Office Action Summary	Application No. 10/581,021	Applicant(s) KIM ET AL.	
	Examiner Joshua Benitez	Art Unit 2829

DETAILED ACTION

1. Claims 1-6 of U. S. Application No. 10/581,021 filed on 06/07/2006 are presented for examination.

Fig.2

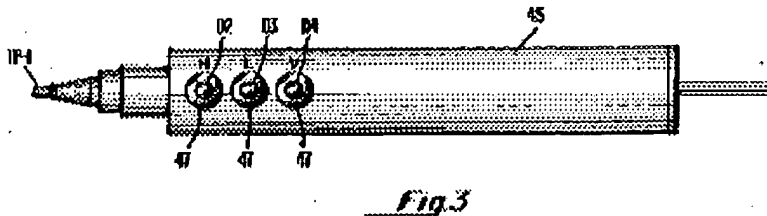
In re claim 1, Shintaku '673 discloses in figures 1-3 a portable electric testing equipment (45) comprising:

- a probe (TP-1);
- ground contact means (43, fig. 2);
- a voltage input unit for receiving a voltage applied from said probe;
- a controller for applying a test voltage of a prescribed level to said voltage input unit (col. 2, lines 39-56); and
- outputting a control signal for indicating a ground (MIDRANGE) when a voltage level inputted from said voltage input unit is below zero level and for indicating a measurement stand-by state (OPEN, col. 3, lines 47-56) when the voltage level is a test voltage level and for indicating a detected voltage level (HIGH) when the voltage level is above a prescribed reference voltage (col. 2, lines 26-37); and

FIG. 1

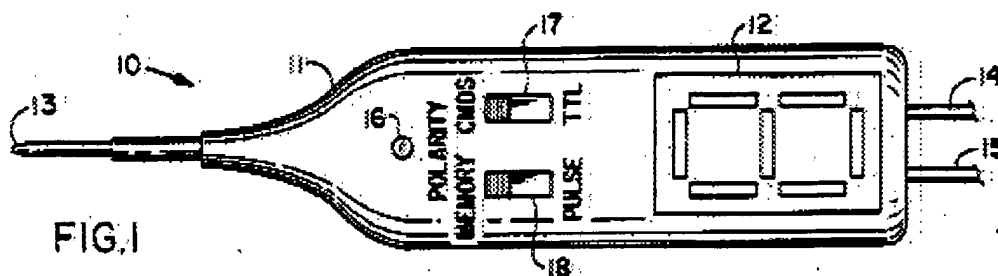
However, Ort '144 does disclose in figure 1 a test system comprising probe extension means (20) having an attachable/detachable coupling unit (22), an extension

Fig.1

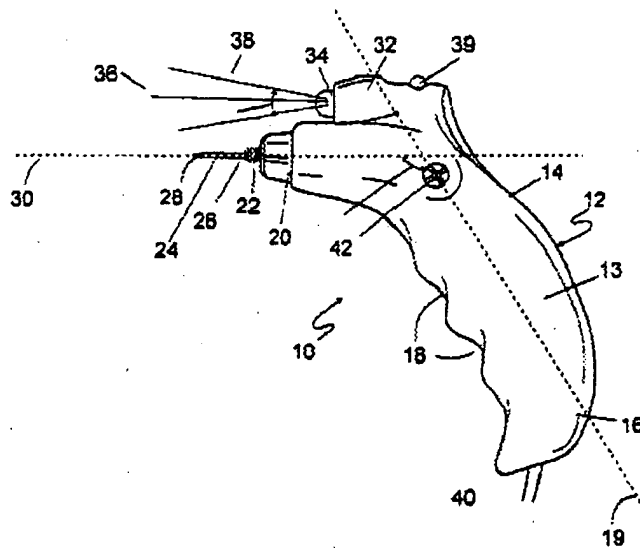
However, Vinci '964 does disclose in figure 1 a portable electric testing equipment (10) comprising an illuminating lamp (34) for illuminating a place at the pointing direction of said probe.

It would have been obvious to a person having ordinary skill in the art at the time the invention was made to have provided the test equipment as taught by Shintaku et al with an illuminating lamp as taught by Vinci et al in order to illuminate the work area in the region of the probe test point (col. 2, lines 36-38, 45-51).
